SUBJECT: SPIRIT LAKE/TROJAN PLANT FLOODING SER

HYDROLOGIC ENGINEERING SAFETY EVALUATION REPORT
CONCERNING A POSTULATED BREAKOUT OF SPIRIT LAKE
AND ITS IMPACTS ON THE TROJAN PLANT

FIGURE 2
LOCATION OF SPIRIT LAKE OUTLET

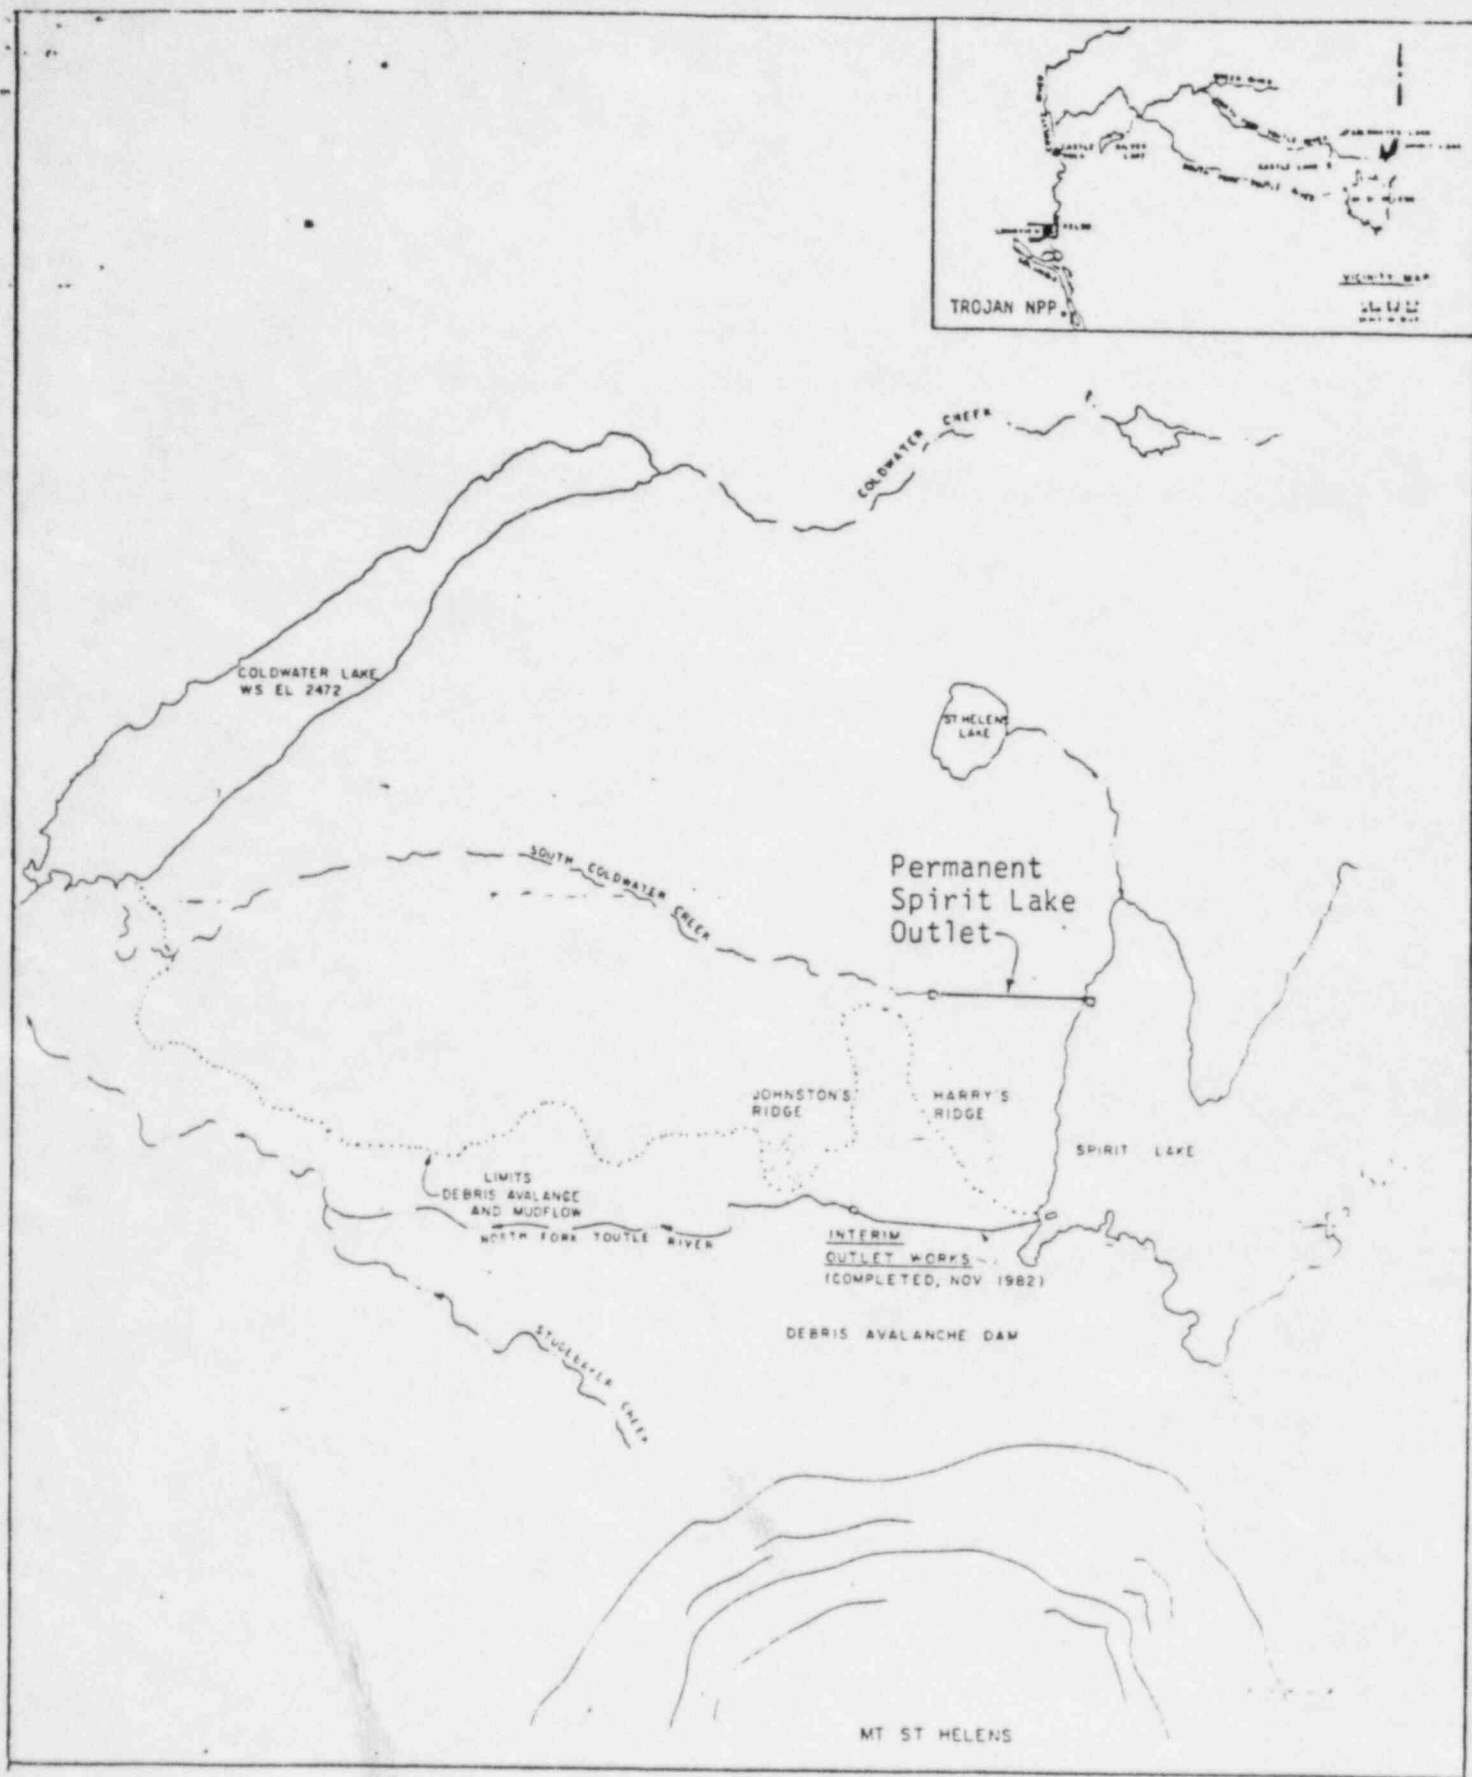
The tunnel being constructed between Spirit Lake and South Coldwater Creek (See Figure 2) will provide a permanent outlet for Spirit Lake. This tunnel will permanently lower the level of Spirit Lake and remove the threat of a breakout and the potential for high water in the Columbia River at the Trojan Plant.
